Powerhouse Ultimo Renewal

Stormwater and Flooding, Response to State Significant Development Comments

Reference: PU2-REP-CI-00X03

B | 15 August 2024

FFL Flood Level Check Sheet 3

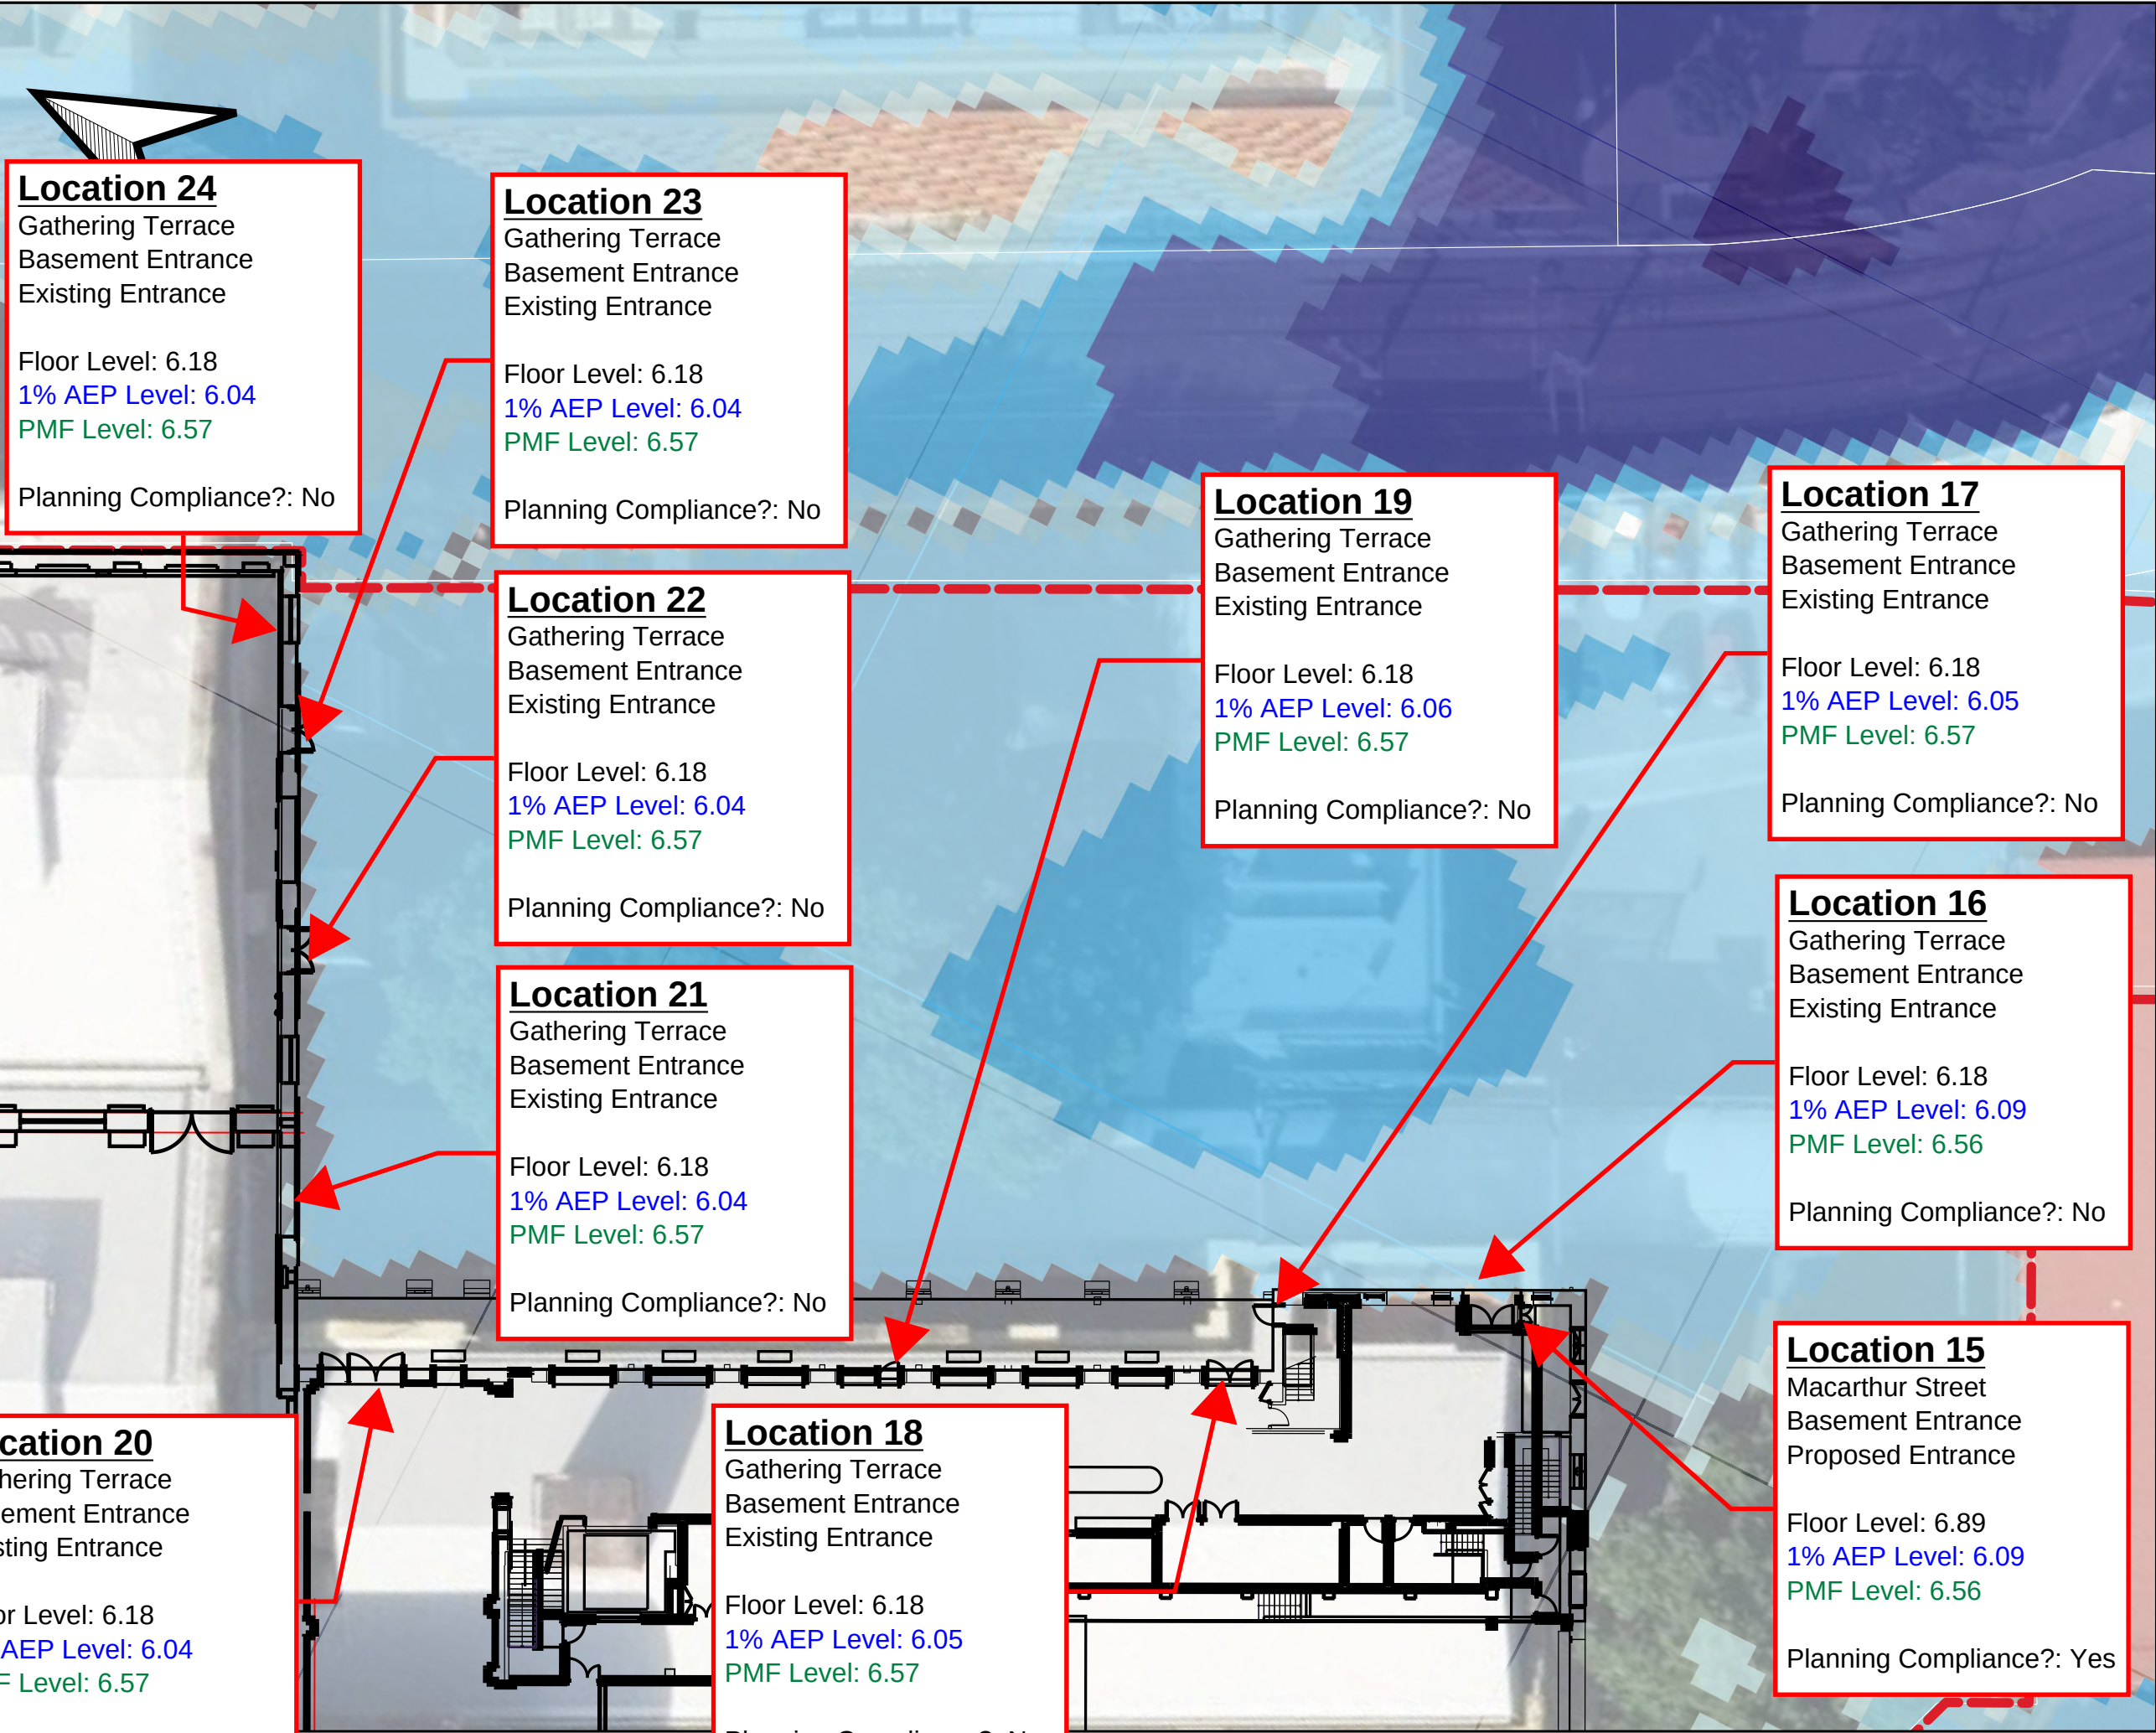
3.2	Clarification on which basement entries are above the Probable Maximum Flood (PMF) and how much freeboard to the 1% Annual Exceedance Probability (AEP) can be provided where 500 mm cannot be reached. Preferably the existing tables would be amended to provide this information.	Refer to Section 2.2 (Table 3) and Appendix A.4 for the updated flood level planning compliance assessment.

Item	Agency Comment	Response
3.3	Consideration of the flood risk should form part of the justification for a lower level, e.g., depth and duration of flooding. Where protection to the PMF level cannot be reached, calculations can be made to estimate the maximum volume of water likely to enter the basement. The resultant maximum depth can inform a risk assessment.	A review of the risks associated with flood water entering the building has been provided, including the depth of inundation (including in basement areas, the consequences (hydraulic hazard, damage to artifacts, etc), Refer to Section 2.2.2.
3.4	It may be preferable to revise Tables 15 and 16 or produce an alternate table to focus only on flood planning level compliance for the purpose of clarity.	Refer to Section 2.2 (Table 3) and Appendix A.4 for the updated flood level planning compliance assessment.

Entrances 16-24 to the proposed Powerhouse Museum building (which are all located within the Gathering Terrace at the south-east of the site) do not achieve the flood planning criteria (the greater of the 1% AEP + 0.5 m or PMF). This result is consistent with the previous Stormwater and Flooding Report (PUR-ARP-REP-CI-000001, Rev 4, 5 April 2024), although the predicted PMF flood levels from the TUFLOW model are higher than those previously reported.

The Gathering Terrace is an existing trapped low point, and the existing Powerhouse buildings adjacent to the Gathering Terrace have heritage significance. The terrace is constrained by the adjacent light rail retaining wall and The Goods Line, which are both elevated above the terrace, plus the existing floor level of the Powerhouse buildings (6.18 m AHD).
